Ordinance No. 2010-M-43

An Ordinance Amending Chapter 15.04 “Building Code”, Section 15.04.020 “One-Family and Two-Family Residences – Regulations Adopted and Modified” of the St. Charles Municipal Code

Ordinance No. 2010-M-43

Figure R403.1 (1)
 Concrete and Masonry Foundation Details

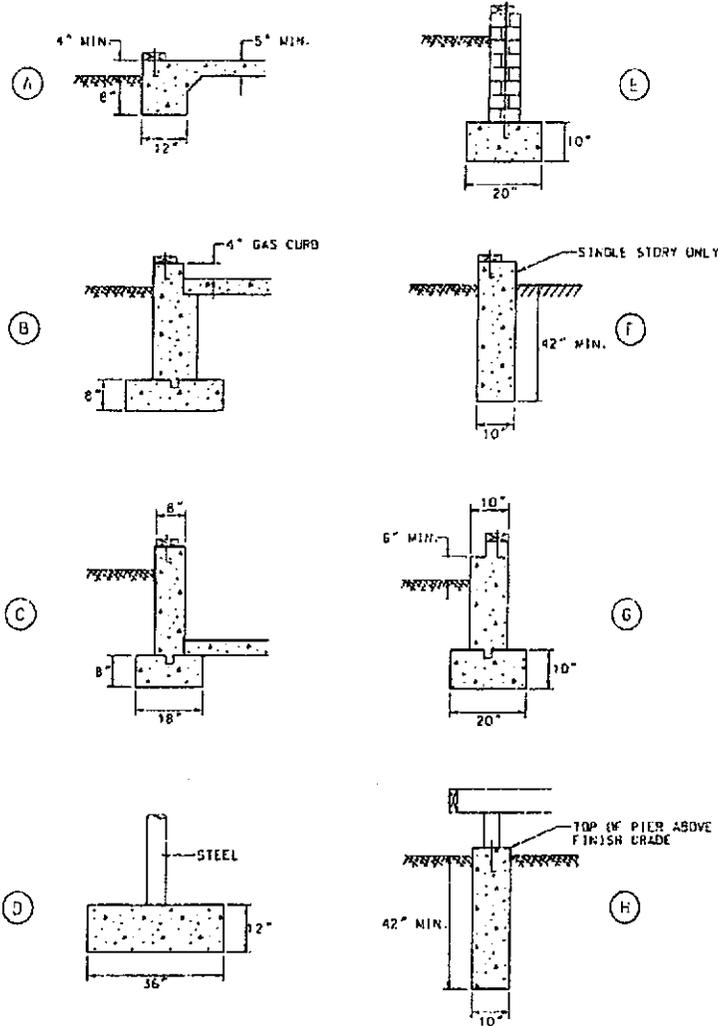
F. **Figure R403.1 (1) Concrete and masonry foundation details:** Delete this figure and substitute the following therefore:

soil conditions warrant a greater width, or so designed and certified by a license design professional, footing projections shall be equal to $\frac{1}{4}$ the width of the footing and the wall must fit center on the footing. Single story structures may be placed on 10-inch wide by 42-inch deep trench footing. Footing thickness shall be a minimum of 8-inches or the same depth as the wall thickness, whichever is greater, or as designed by a licensed design professional. See Figure R403.1 (1) for an illustration.”

- A= Typical turned down garage slab.
- B= Typical foundation detail for attached garage with gas curb.
- C= Typical footing and wall detail.
- D= Typical pier pad for lolly column in basement.
- E= Typical footing and wall detail for masonry block wall.
- F= Typical trench foundation.
- G= Typical wall and footing for brick veneer home.
- H= Typical posthole detail for deck.
